Summary Title: 1700 & 1730 Embarcadero Rd: Appeal of Director's Decision

Title: QUASI-JUDICIAL. 1700-1730 Embarcadero Road [20APL-00002 and 19PLN-00291]: Appeal of Director's Approval of a Major Architectural Review to Address the Following Outstanding Issues for a Previously Approved Auto Dealership Project: Color, Landscaping, Parapets, Lighting, Transportation Demand Management Plan, County Airport Land Use Commission Review; and Floor Area Ratio. Environmental Assessment: Addendum to an Initial Study/Mitigated Negative Declaration That was Adopted for the Project on June 24, 2019. Zoning District: CS(D)(AD)

Re: Letter Stating Reasons for Appeal of the Project at 1700 and 1730 Embarcadero Road, Palo Alto (19PLN-00291)

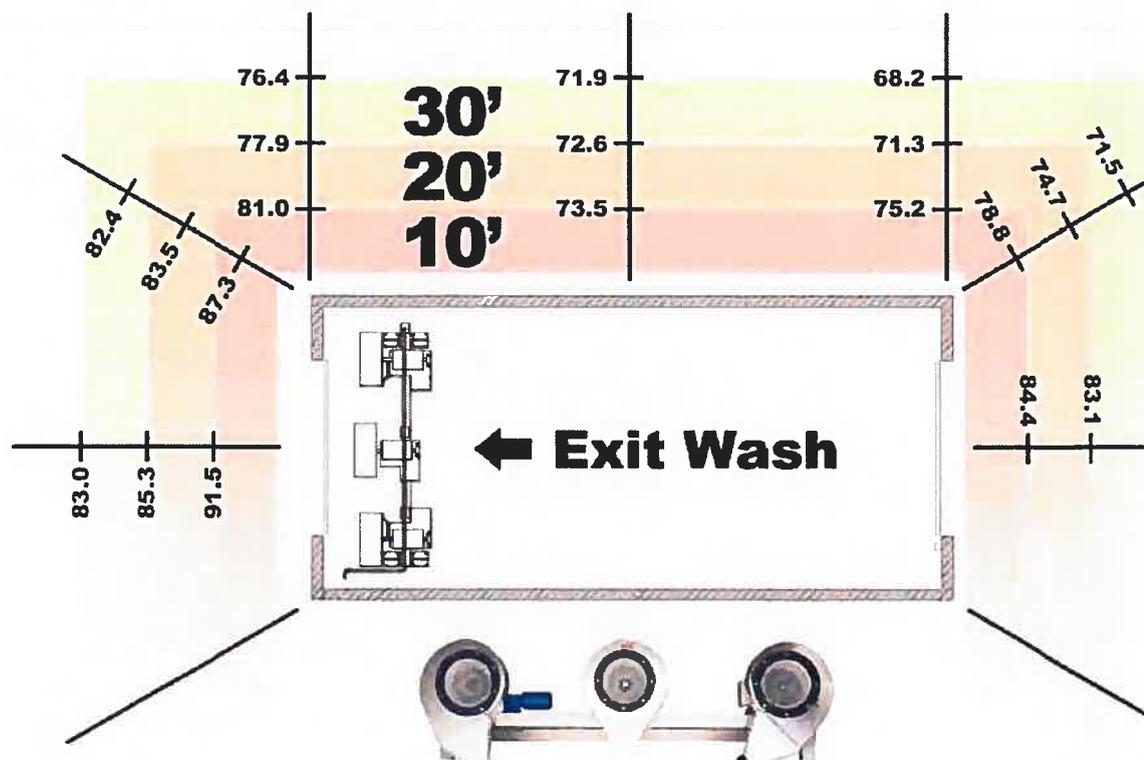
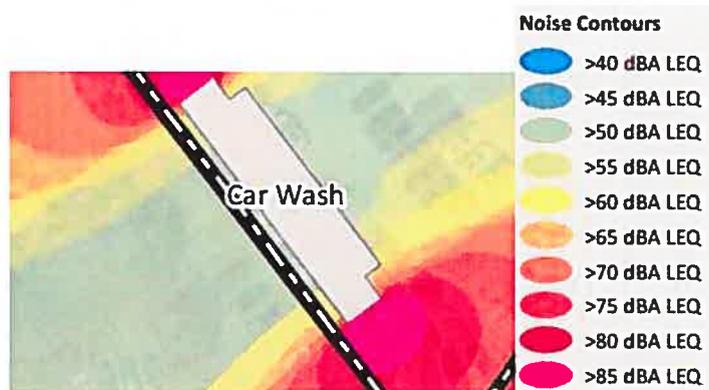
According to the noise study submitted by the applicant prepared by Helix Environmental Planning (“Noise Report”): “The loudest single source is the air-blast drying systems (blower) just inside the car wash exit. The blower units to be used at the project’s car wash are a Broadway Equipment Company 45 horsepower assembly. The manufacturer’s data sheet indicates that the blowers would generate a noise level of 83.0 dBA at a distance of 30 feet from the car wash tunnel exit, and a noise level of 79.1 dBA at a distance of 30 feet from the car wash tunnel entrance, with the car wash tunnel doors open.”

While the Noise Report proposes a mitigating measure involving an automated door, the projected 49.8 dBA with the doors closed is measured at the *south corner of the Project’s property, rather than along Gwin’s property border*. Even with the doors closed, there would be substantial noise along the property line adjoining Gwin. Further, the noise contours in the Noise Report

labeled as Figure 4 and Figure 5 conflict with the manufacturer's data sheet attached to the Noise Report as Appendix C.

- (1) It does not address noise levels at the property line adjoining Gwin in Table 6.
- (2) Figures 4 and 5 showing noise contours are incorrect.
 - a. The noise contour in Figure 4 (door open) indicates that the noise level is 50 dBA adjacent to the side wall of the car wash ("Adjacent Side Wall Area"). This contradicts the manufacturer's measurement which is 71.9 dBA to 73.5 dBA. This is a significant difference of more than 20 dBA which is under reported with identical conditions. See Appendix C to Noise Report.

- b. Similarly, the noise contour in Figure 5 (closed doors) shows no detectable/less than 40 dBA of noise at the Adjacent Side Wall Area which is erroneous:

While our primary preference would be the removal of the car wash structure from the Project in its entirety, we are willing to accept as a compromise installation of a sound insulating wall along the northeast border adjoining the properties. The wall may be built with a solid wood

frame with rigid insulation in between, or a metal frame with rigid insulation in between and coated with stucco finish. The wall should be of sufficient thickness and height to insulate noise pollution to a two-story office building based on reports from qualified acoustic engineers.

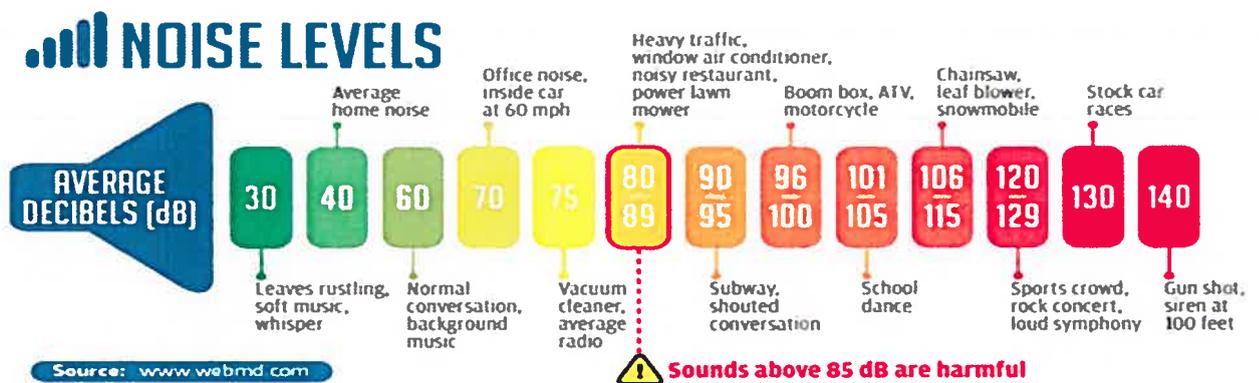
Given these issues in the Noise Report, the proposed mitigating measure and claimed result of 49.8 dBA (which is below ambient) from closed doors is unrealistic. Considering these discrepancies, it is unlikely that the applicant can comply with PAMC 9.10.040's restriction that noise level not exceed 8 decibels above the local ambient.

Put simply, if the blowers are on during a car wash, you can hear it loud and clear. To provide some perspective, the blower's noise level² is equivalent to a power lawn mower and is harmful to hearing:
